Comments on #SDP-26-0004 - Planning & Zoning: Site Development Plan

Application Number: #SDP-26-0004
Application Type: Site Development Plan
Date: August 12, 2026
Address: 705 S MAIN ST, ROLESVILLE, NC 27571
Parcel: 1758574058

WALLBROOK SHOPPES (LOT 5C)

Town of Rolesville Project No. SDP 26-0004

PLAN / PROFILE - PRIVATE SAN. SEWER
WALLBROOK SHOPPES (LOT 5C)
Town of Rolesville Project No. SDP 26-0004
Wake Forest Township, Town of Rolesville, Wake County, North Carolina

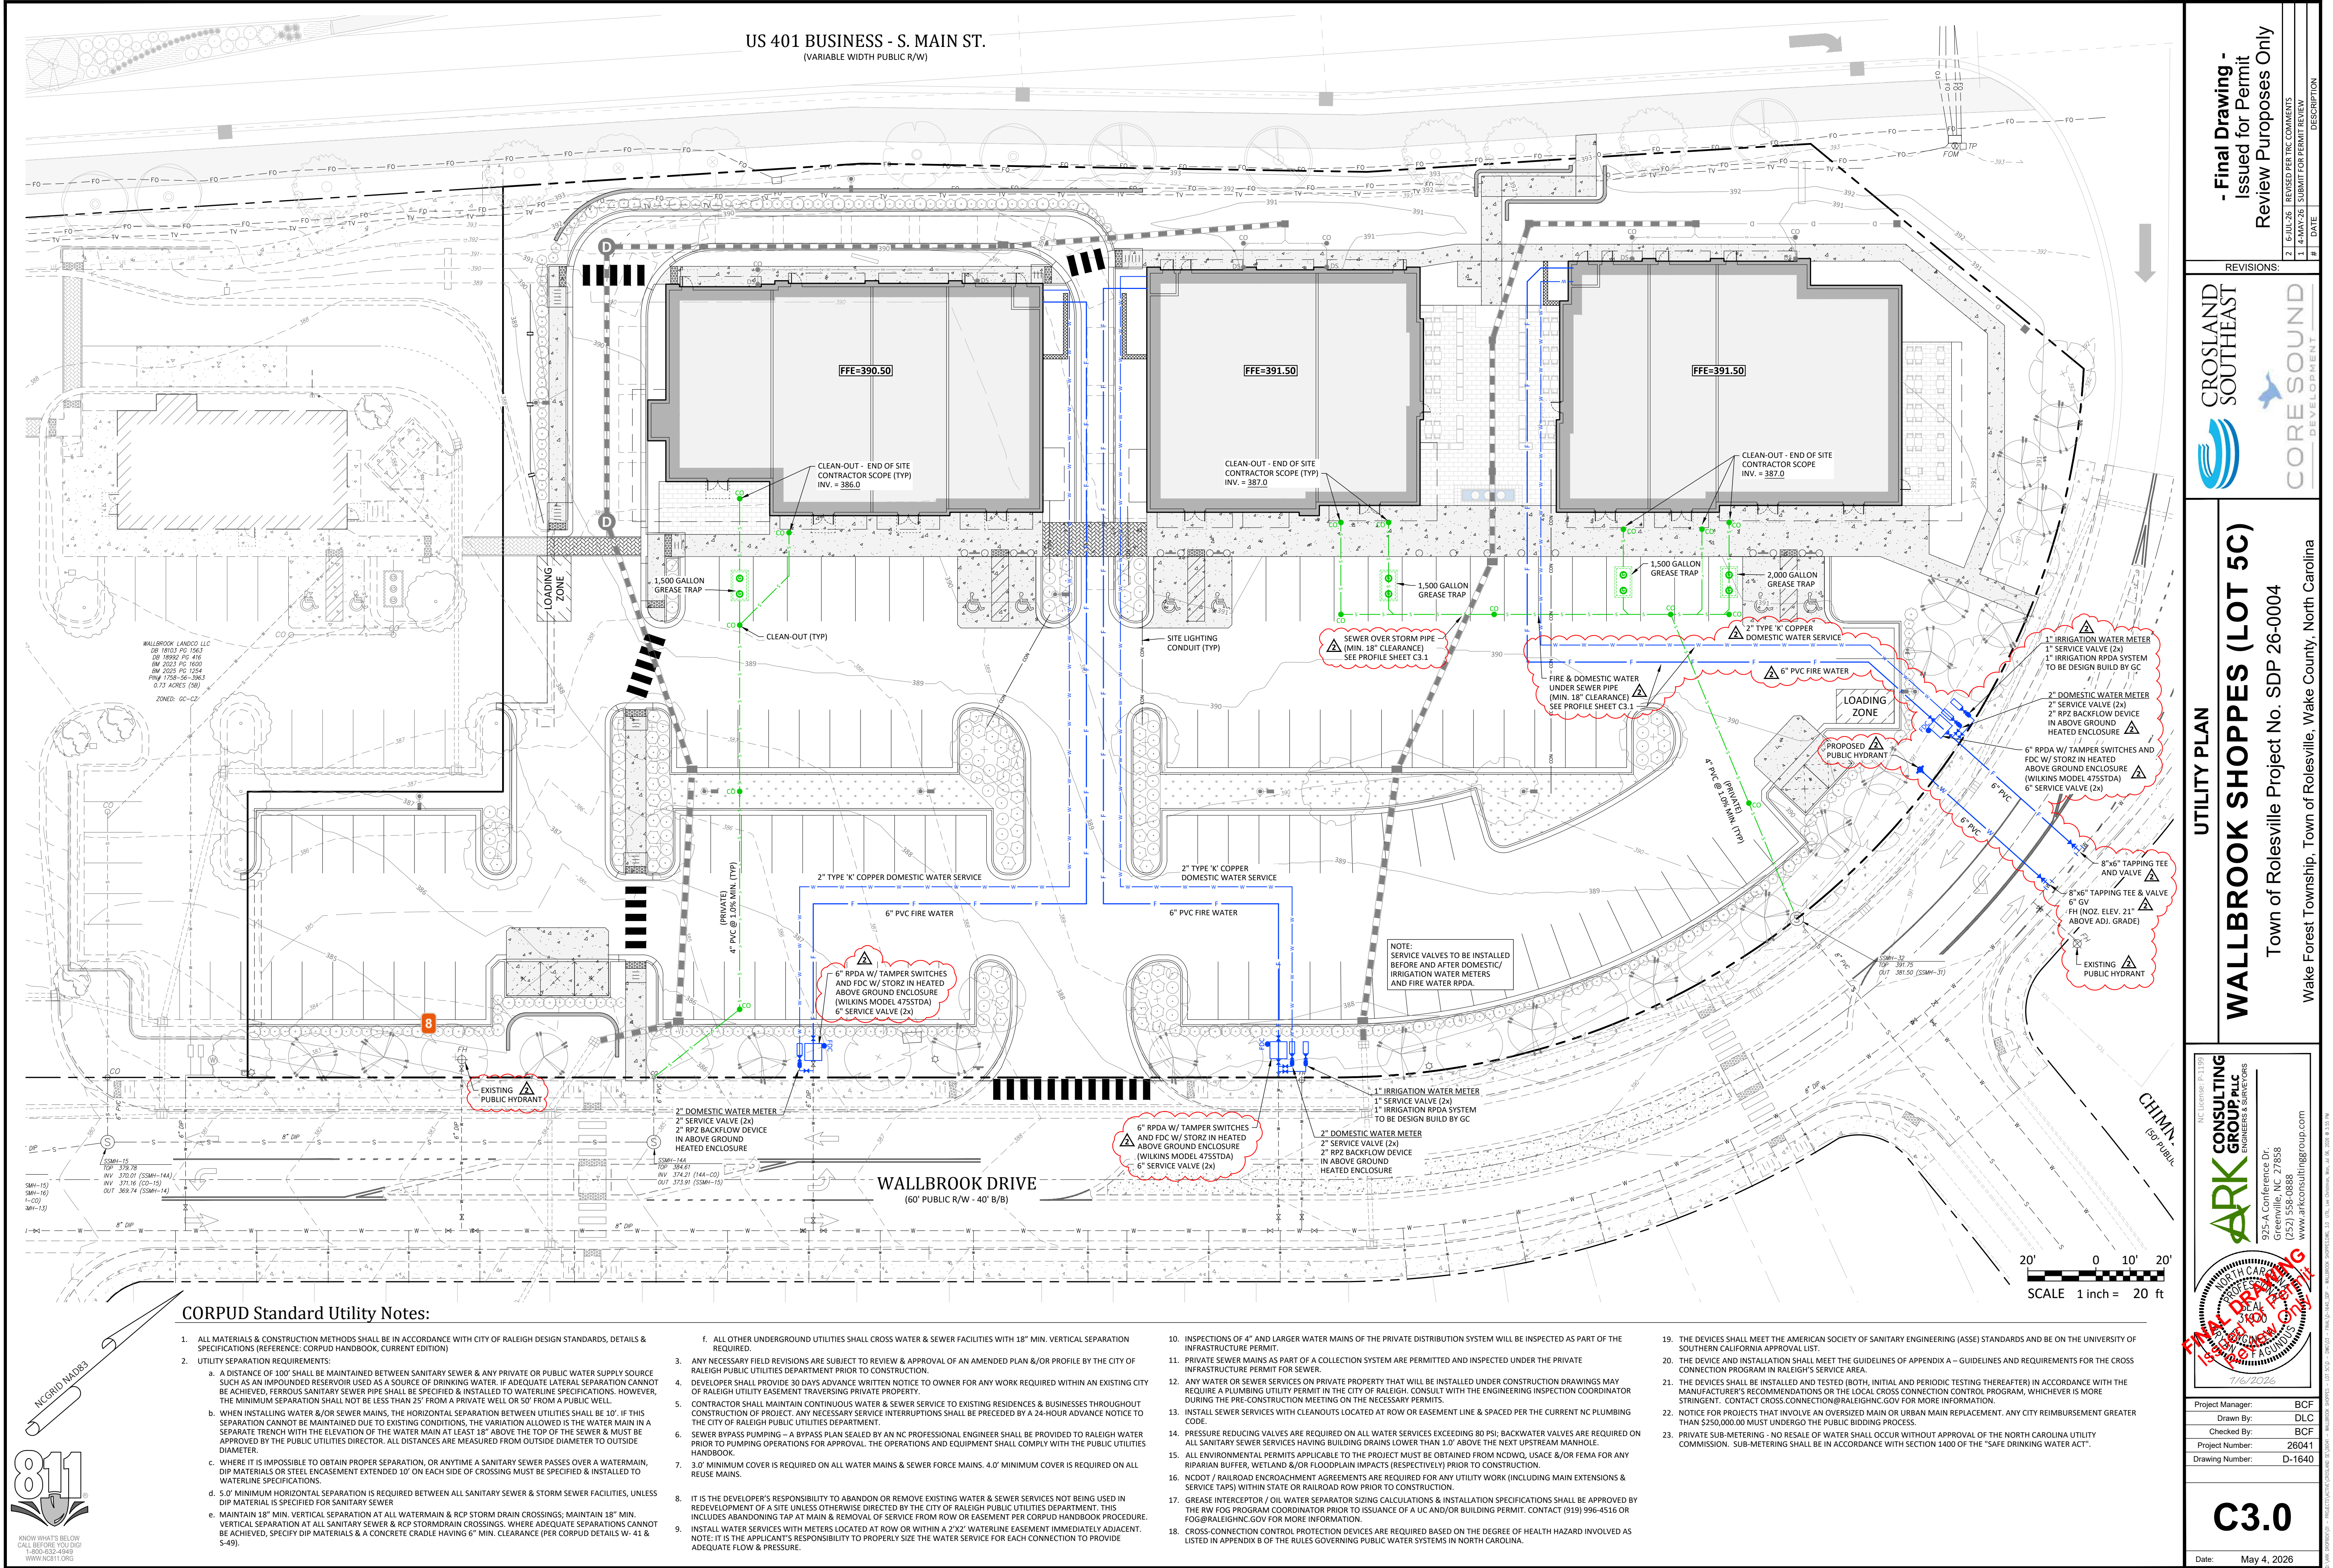
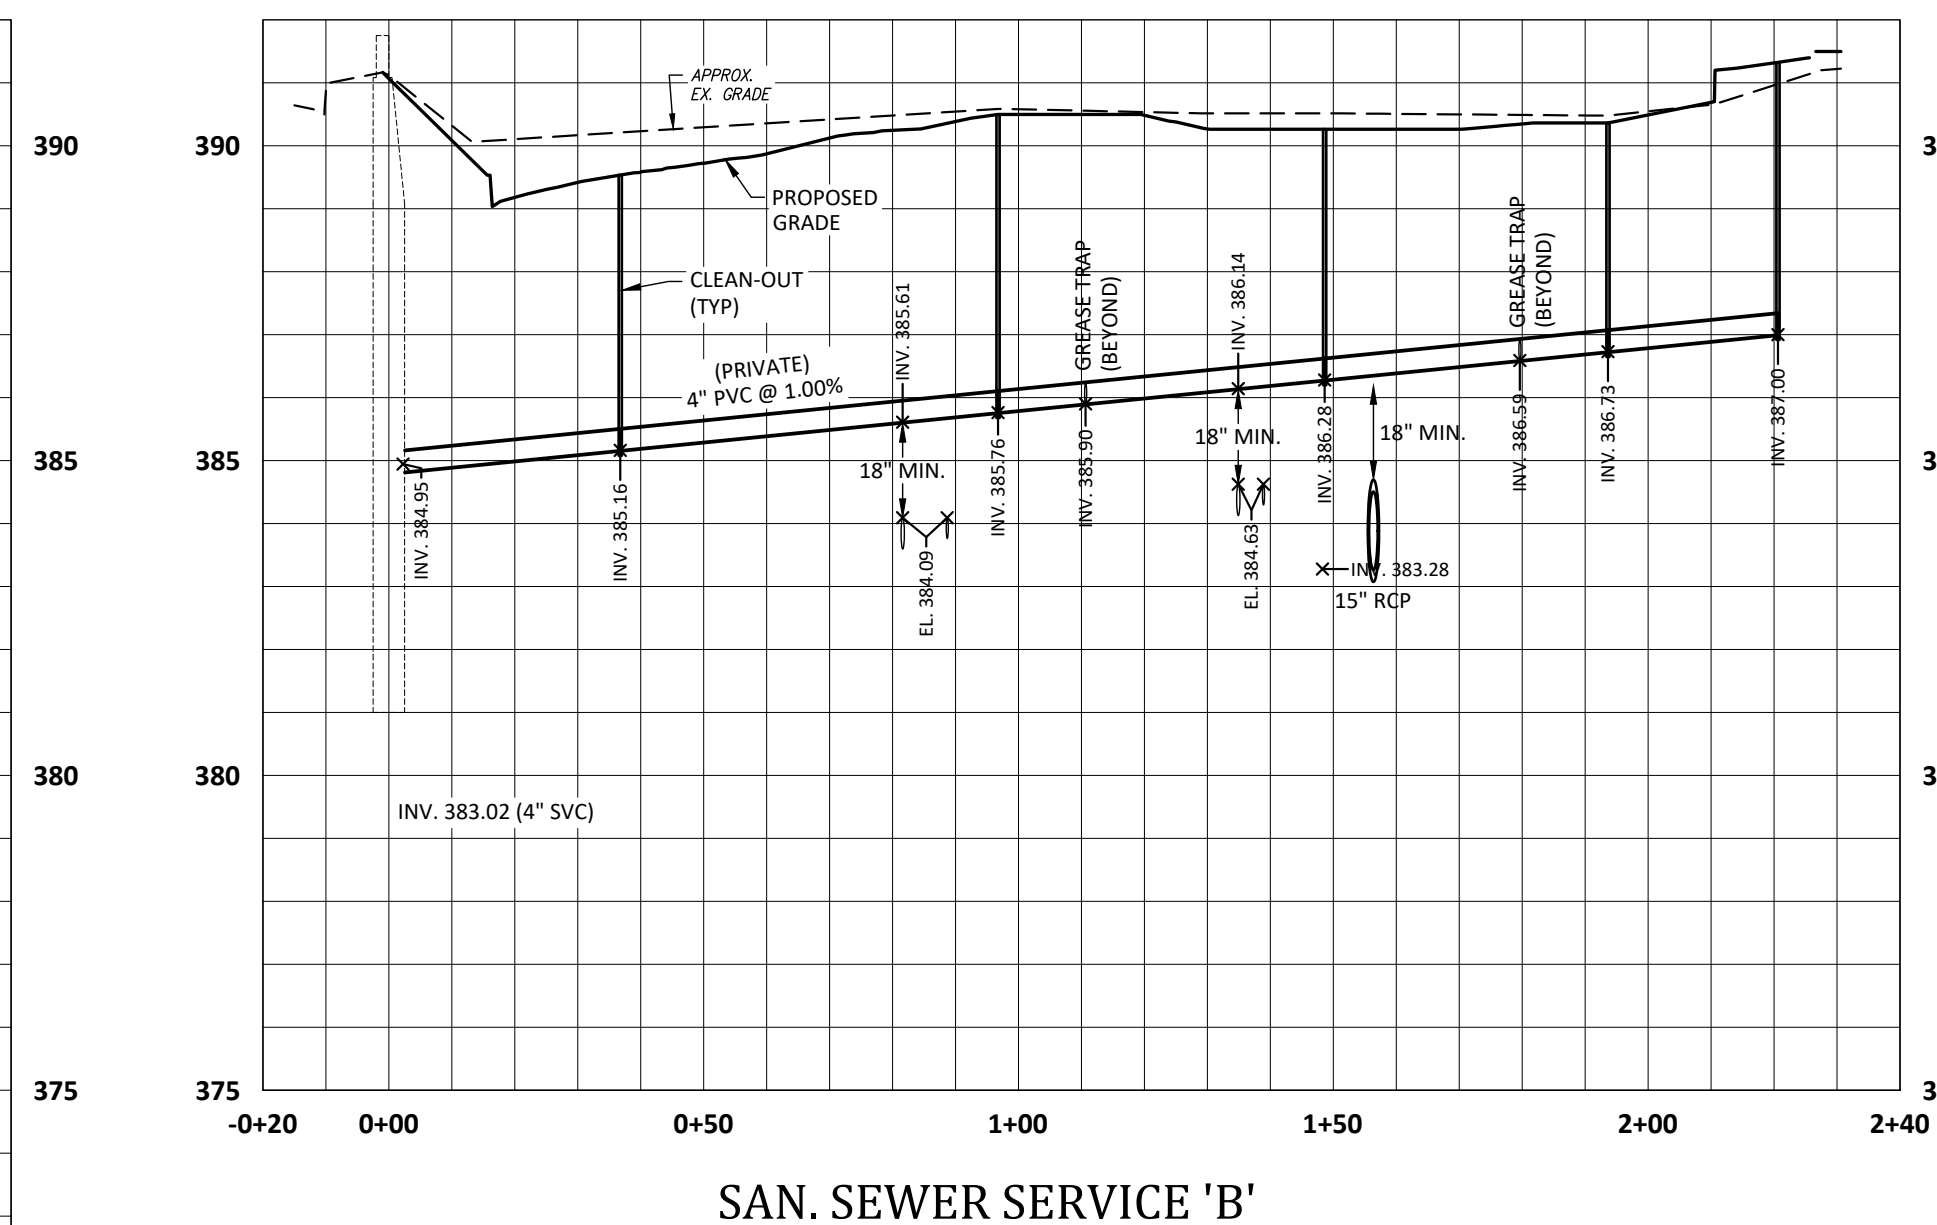
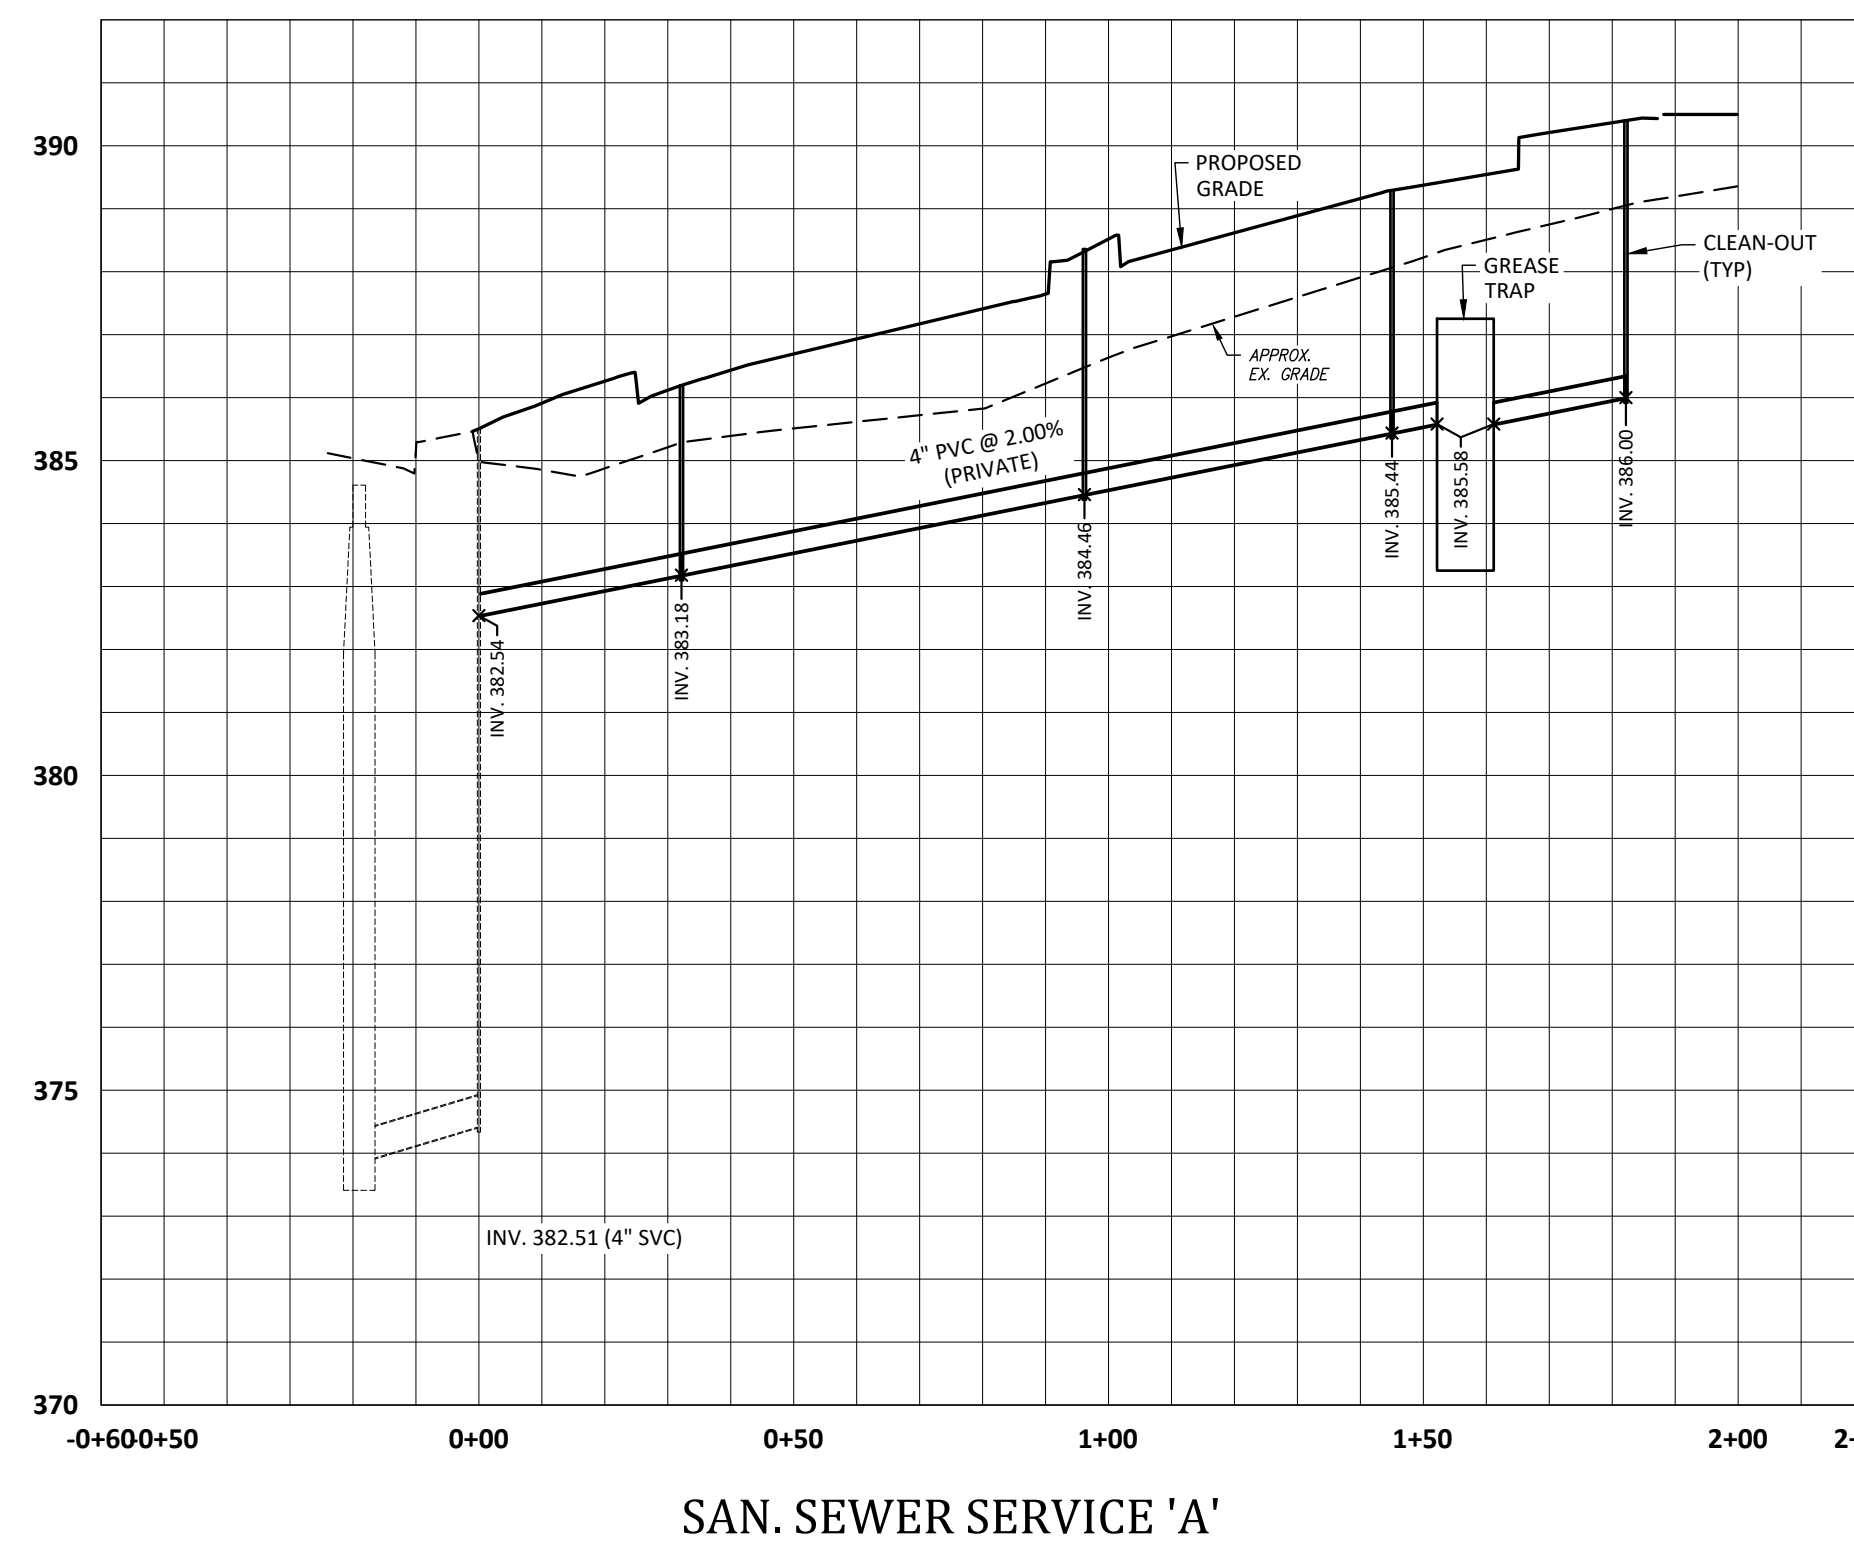
Please include a typical section/detail for bicycle parking with a rack to meet the requirements of LDO Section 6.4.7
- 5 Jacqueline Thompson

Please include the easement width in the label.
- 6 Jacqueline Thompson
